To All vendors: Addendum #4

Fire Lane & Walking Track Improvements

This addendum serves as a notice of change in the Scope of Work for proposals of the RFCSP.

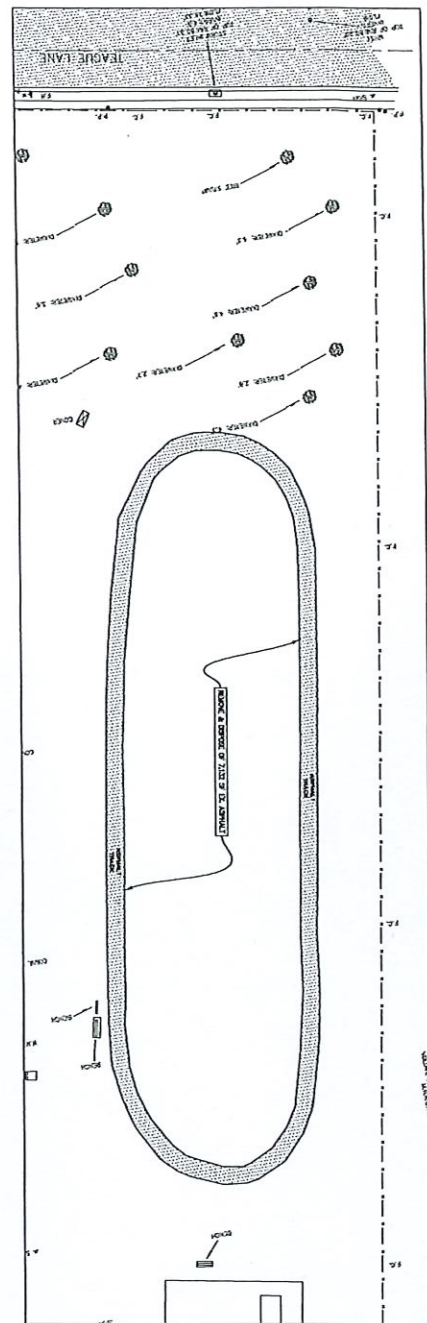
After further review of the existing Scope of Work regarding the Magee Intermediate Walking Track, it is the intent of the district to include additional flat work under an existing shade canopy adjacent to the track. This flat work will be approximately 33' x 33' and will connect with the proposed walking track with a 5' wide side walk which will be approximately 3' in length.

The thickness of the new flat work under the canopy and subgrade are to be constructed with the equivalent specifications of the walking track.
